Amendment to Berm Wall Pack 2 (Northern extent of Euston Cavern Headhouse to Parkway Tunnels) - Park Village East Wall S1

Schedule 17 Plans and Specifications Written Statement for Information

LBC.PS.10014

Document Reference: 1MC03-SCJ_SDH-IN-STA-SS01_SL03-000005

Figure 4 Comparison of finish between approved and amendment schemes.

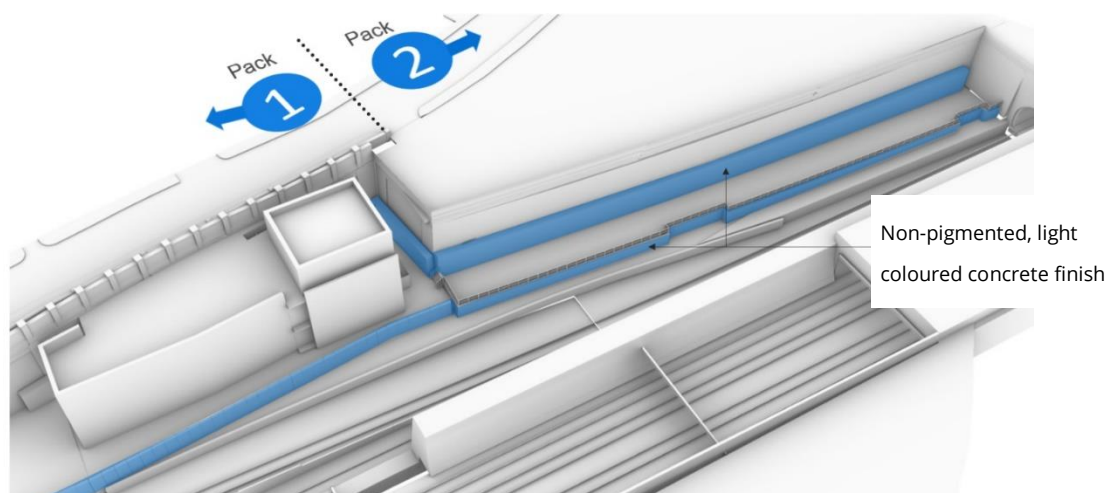
3.4.3 The key amendments in the current submission (**Figures 4 - 6**) include:

- Substantial reduction in mass to a shallower, slimmer berm structure
- Addition of rear wall (known as upstand) against existing cutting wall
- Replacement of rail-side wall (known as L-shaped wall) to a 2m wall with handrail protection
- Addition of maintenance access stairs and associated handrail
- Change of finish to non-pigmented concrete.

Figure 6 Comparison of sections views of approved and proposed schemes.

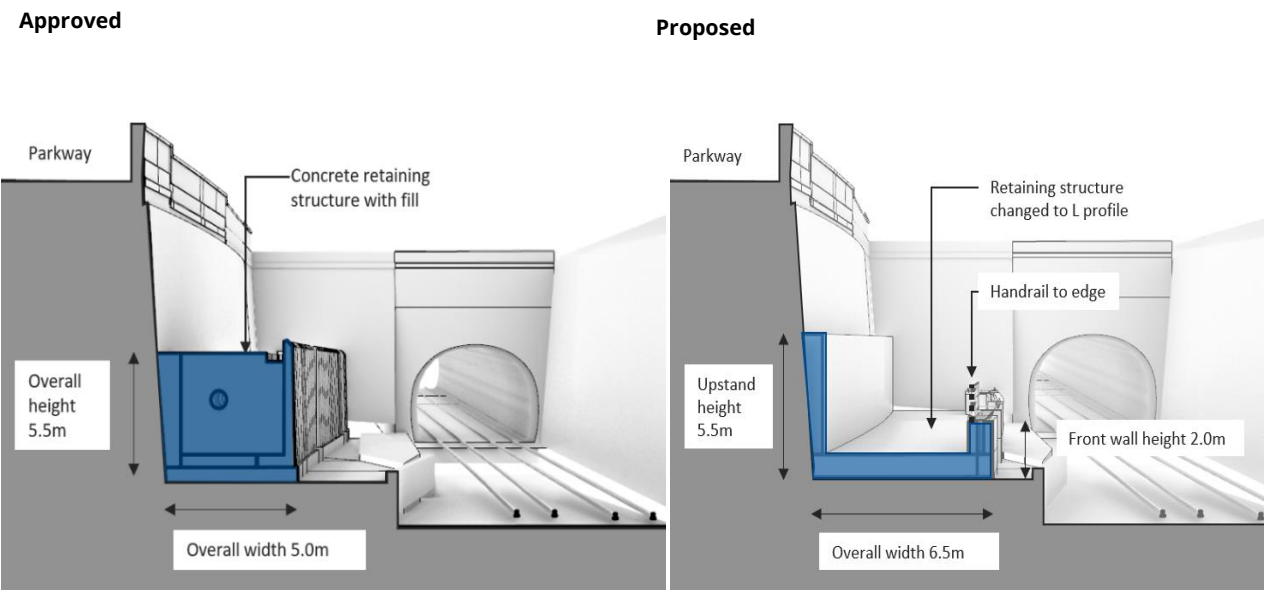
3.3.7 The north section of the Berm Wall will be around 3m in height with a typical width of 7.5m. It will therefore be lower in height and wider than the original approved Berm Wall, which was approx. 4m in height and approx. 6m in width.
